From: WELLS Russell (RS/NB)
Sent: Friday, March 18, 2011 4:43 PM
To: 'Tesfaye, Getachew'
Cc: DELANO Karen (RS/NB); ROMINE Judy (RS/NB); BENNETT Kathy (RS/NB); CORNELL Veronica (External RS/NB)
Subject: Response to U.S. EPR Design Certification Application RAI No. 376, FSAR Ch. 3, Supplement 18

Subject: Draft Response to U.S. EPR Design Certification Application RAI No. 376,
FSAR Ch. 3, Question 03.08.05-25
Sent Date: 3/18/2011 6:47:32 PM
Received Date: 3/18/2011 6:48:08 PM
From: WELLS Russell (AREVA)

**Request for Additional Information No. 376
Question 03.08.05-25 Revision 1**

Question 03.08.05-25:**Follow-up to RAI 155, Question 03.08.05-5**

Figure 03.08.05-25-1 Foundation Modulus for High Frequency Soil Cases

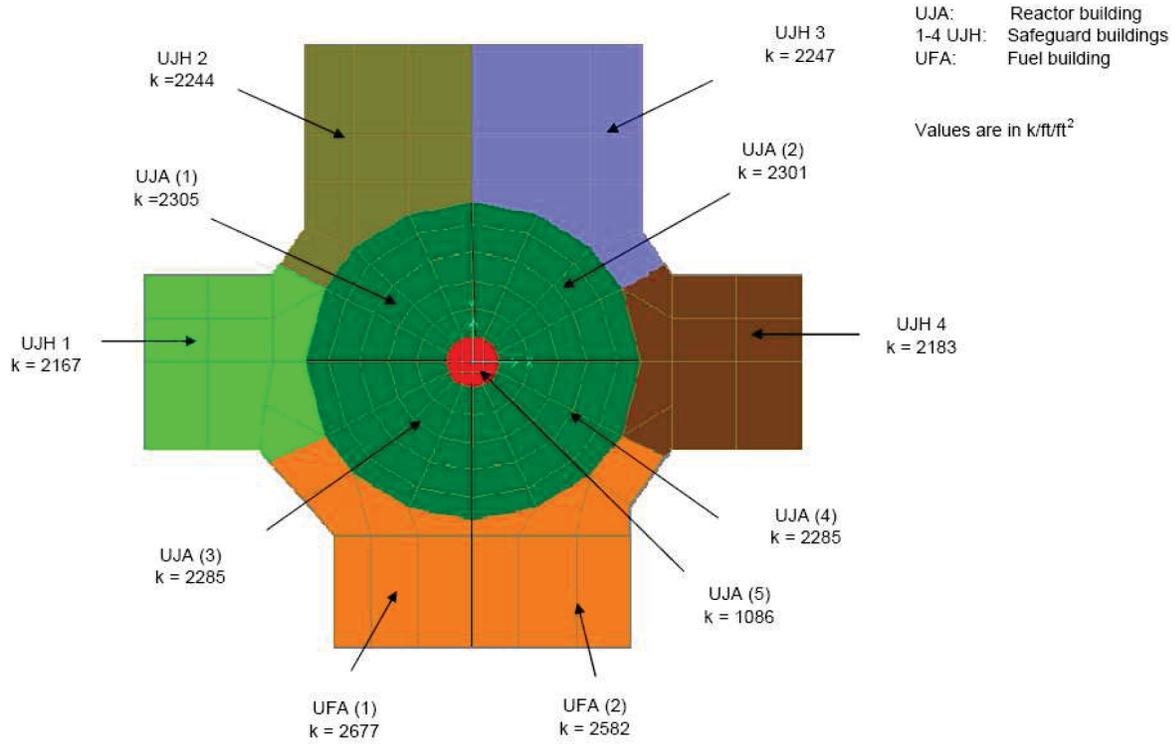
3. The response to Item 3 of this RAI does not address the intent of the original RAI, which requests AREVA to discuss the issue of variability of soil conditions (i.e., stiff and soft spots in the foundation soil), and their effect in the design of the NI foundation basemat. The staff notes that FSAR Section 2.5.4.10.3 states that, "The design of the U.S. EPR is based on analyses that assume the underlying layers of soil and rock are horizontal with uniform properties. Furthermore, the U.S. EPR is designed for application at a site where the foundation conditions do not have extreme variation within the foundation footprints. However, the design does have margin that allows for adaptation to many sites that might be classified as non-uniform or having highly variable properties." From this statement, it follows that allowance for horizontal variability of soil conditions should be an important design consideration. The RAI response indicates that the softest soil case 1u bounds the design NI foundation basemat. It is not clear, however, if the design of the basemat has considered the potential effects of horizontal variability of soil conditions. Therefore, as requested in the original RAI, describe what studies were performed to evaluate the effects of different soil stiffnesses across the foundation footprint (e.g., higher soil stiffness in the central portion with lower soil stiffness beyond the center, and vice versa), or provide the technical basis for not doing such a study.

U.S. EPR FSAR Tier 2, Table 3.8-13 will be revised to reflect the current soil cases and a new figure (Figure 3.8-145) will be added to show the soil spring distribution for the high frequency soil cases. U.S. EPR FSAR Tier 2, Section 3.8.5.4.2 will be revised to include the high frequency soil case spring distribution.

There are two aspects of horizontal variability to consider within each soil layer, 1) the distribution of the foundation modulus, and 2) the physical properties of the soil. The distribution of the foundation modulus for each soil case is provided in U.S. EPR FSAR Tier 2, Table 3.8-13 and Figure 03.08.05-25-1. The soil physical properties are described in U.S. EPR FSAR Tier 2, Sections 2.5 and 3.7 and are assumed to be uniform within a soil layer.

The high frequency soil cases (hfub, hfbe and hflb) are based on a site-specific rock site distribution where a foundation modulus is determined for each NI common basemat structure (see Figure 3.8-145).
